Subject: RATTLE NOISE FROM FRONT DOOR GLASS	Bulletin No: 09-055/16
	Last Issued: 10/25/2016

BULLETIN NOTE

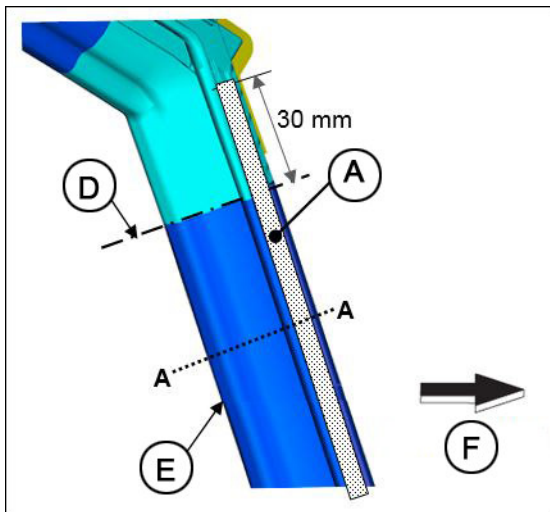
3. Install pieces of the non-woven fabric (KAY0-58-871) to the new glass run channel.
 - a. Cut the non-woven fabric sheet (100mm X 150mm X 1mm) into the following sizes and pieces.

Sheet A:	6mm X 140mm	1 piece
Sheet B:	5mm X 100mm	2 pieces
Sheet C:	8mm X 25mm	2 pieces

Attach Sheet A

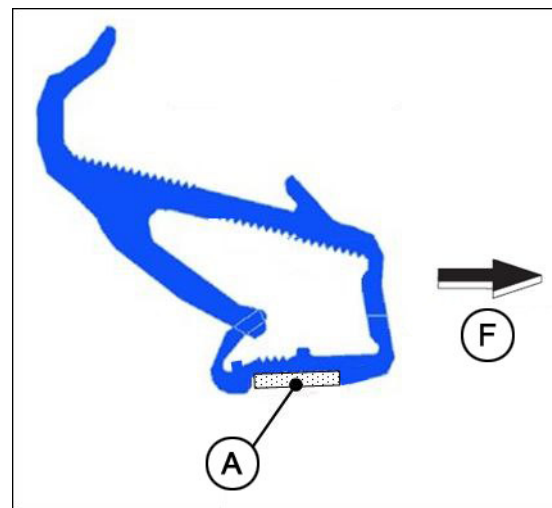
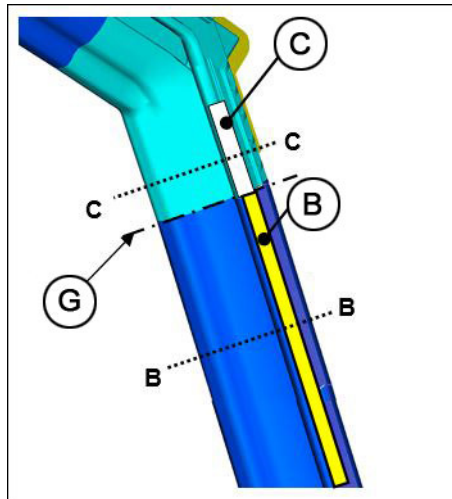
Attach Sheet A to the outside groove of the new glass run channel as shown.

A: Sheet A - Attach 30mm above the joint line (D).
D: Molded Joint Line
E: New Glass Run Channel
F: Vehicle Front

Cross Section A-A

A: Sheet A - Attach in the groove of the outside of the new glass run channel.
F: Vehicle Front

Attach Sheet B and C

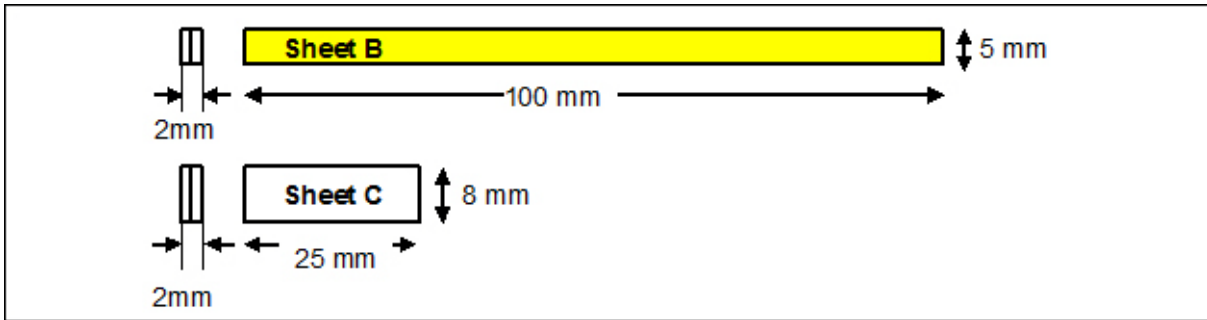
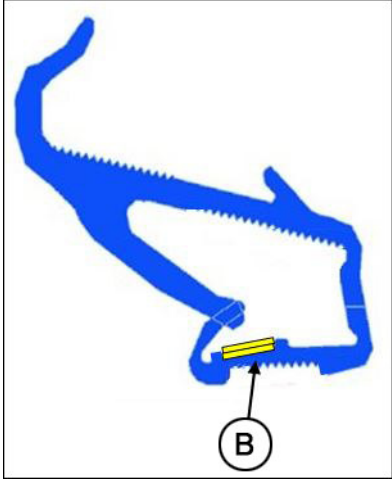
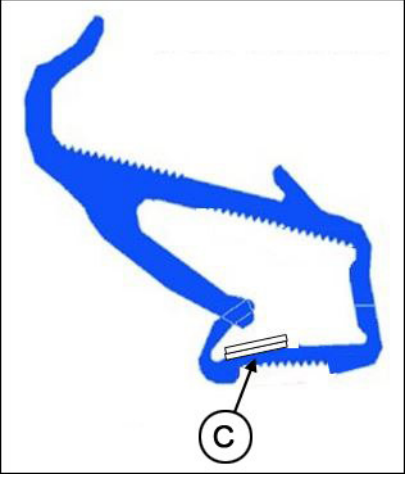
Attached Sheet B and Sheet C to the inner side of the glass run channel as shown.
Note: Sheet B and Sheet C are double stacked.

B: Sheet B - Attach under joint line (G).
C: Sheet C - Attach above joint line (G).
G: Joint Line

Cross Section B-B	Cross Section C-C

<p>B: Sheet B - Attach to the groove of the new glass run channel inner side.</p>	<p>C: Sheet C - Attach to the inner side of new glass channel.</p>
